## Penrith Council Local Planning Panel

31-32 Park Avenue Kingswood (DA20/0729)

KEY CHANGES TO ADDRESS COUNCIL'S CONCERNS:

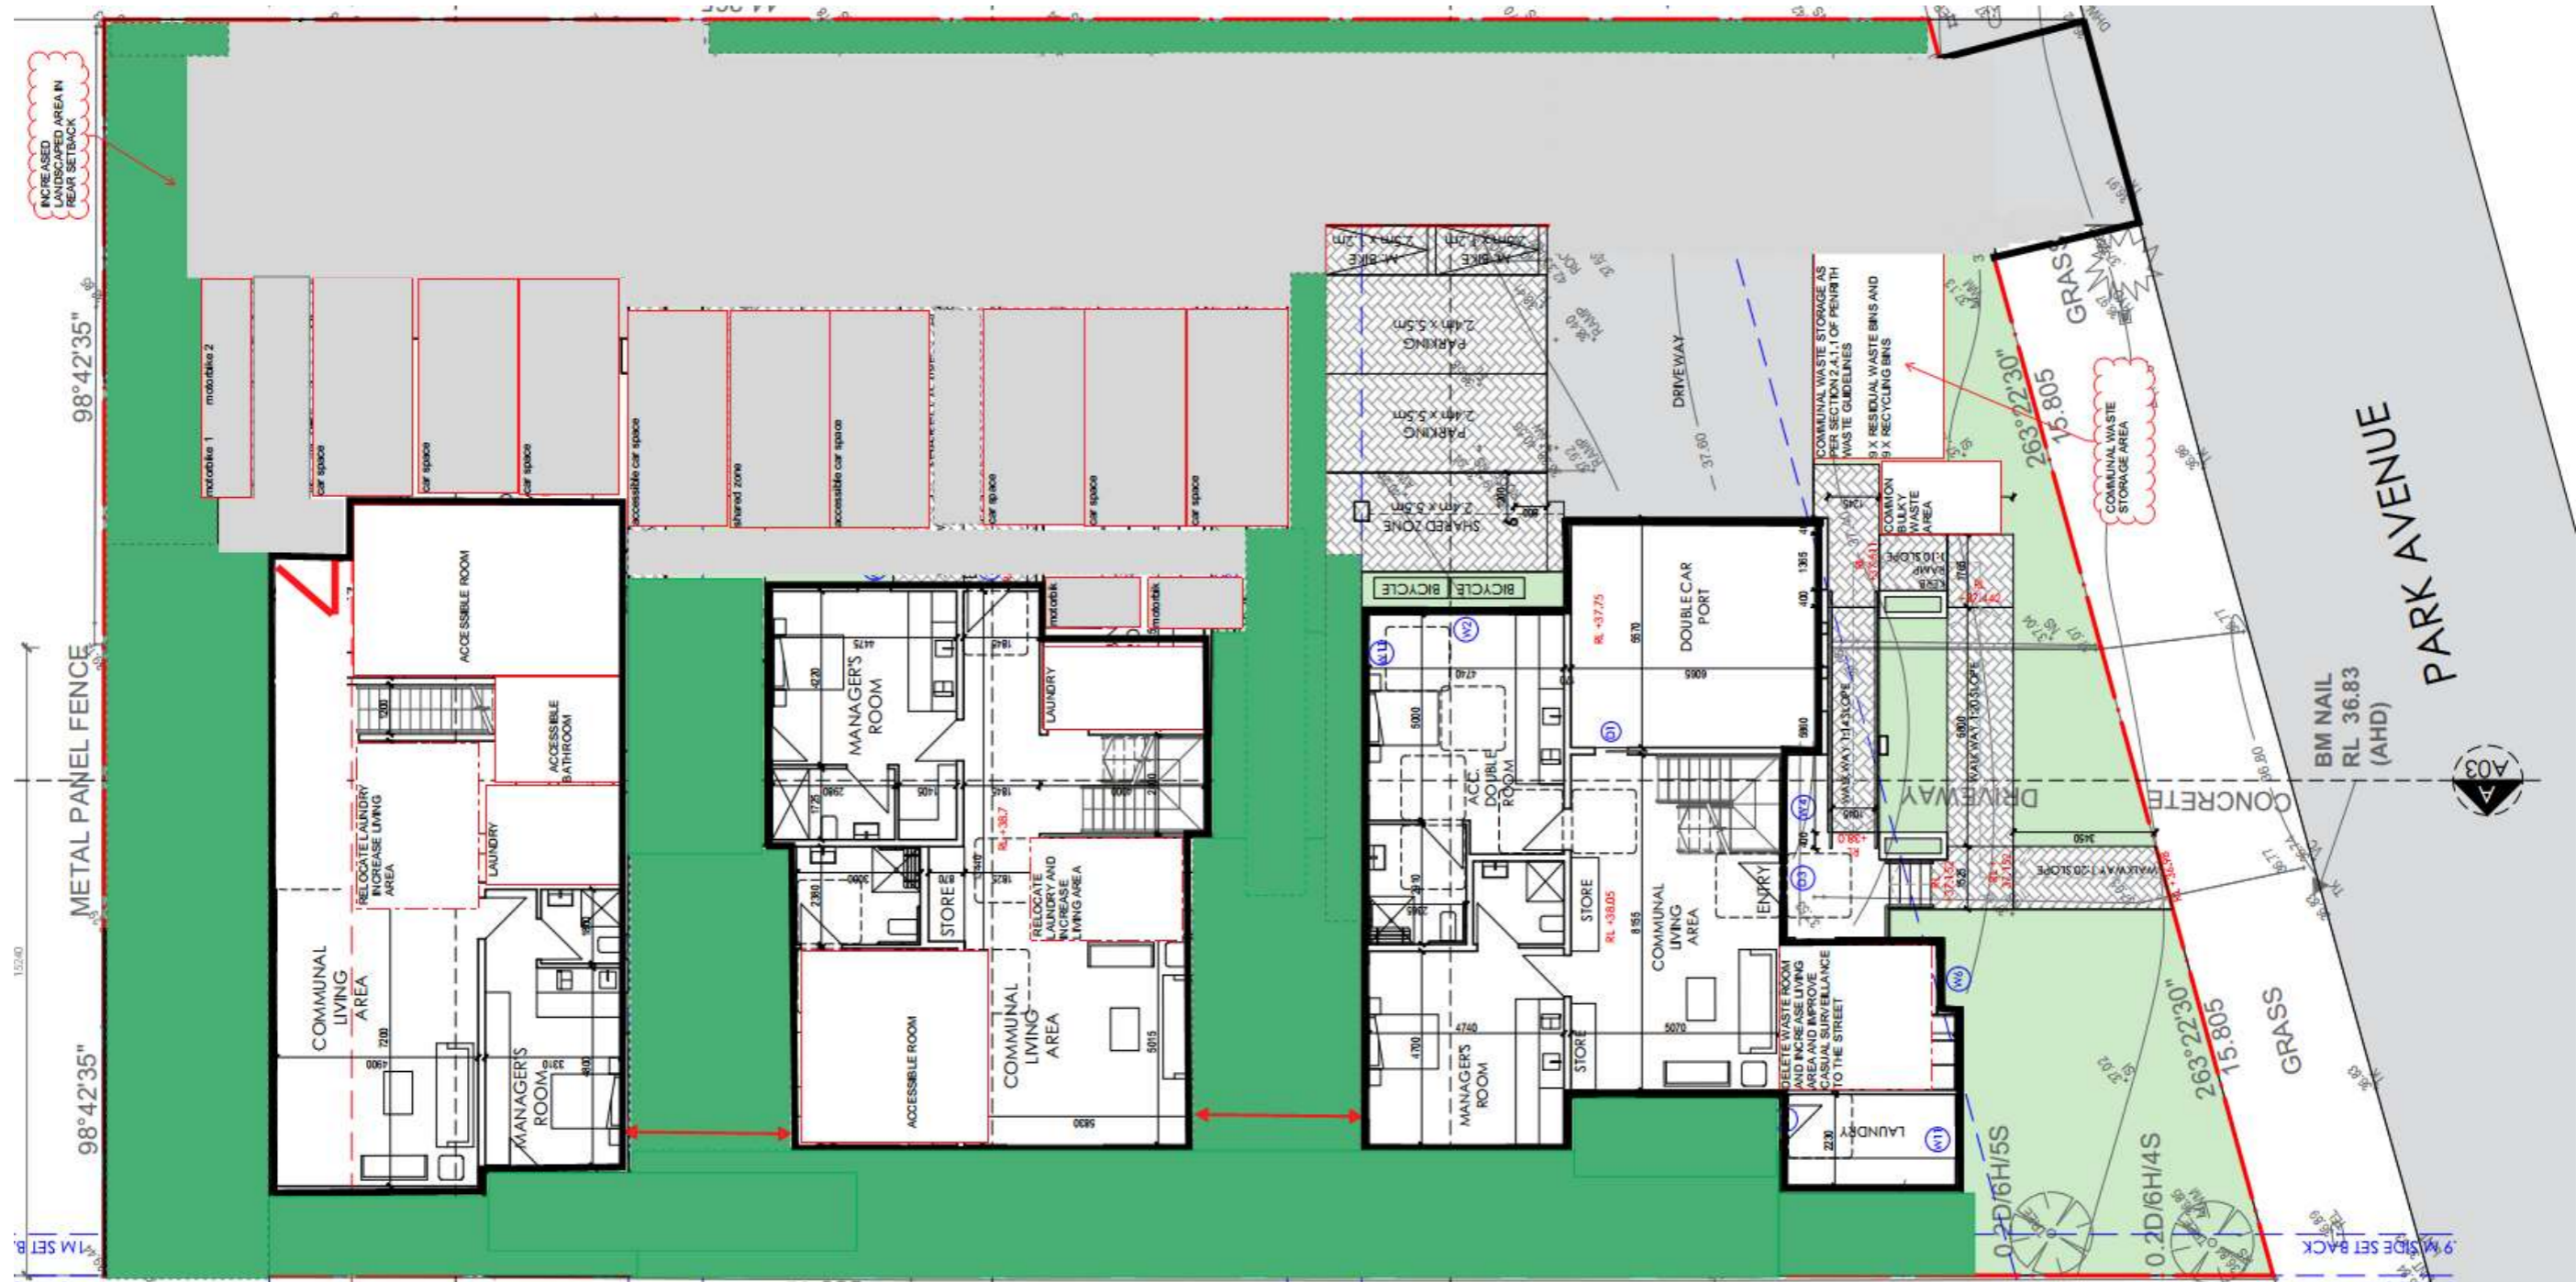
1. TORRENS SUBDIVISION DELETED
2. REVISED PARKING CONFIGURATION TO INCREASE REAR SETBACK LANDSCAPING AND PROVIDE LANDSCAPE STRIP ADJACENT TO DRIVEWAY
3. MINOR BUILDING ADJUSTMENTS TO INCREASE SEPARATION FROM 3.6M TO 4M AND IMPROVE ENTRY ARRANGEMENTS AND INTERNAL AMENITY
4. COMMUNAL WASTE STORAGE AREA ADJACENT TO DRIVEWAY AS PER COUNCIL'S REQUIREMENTS
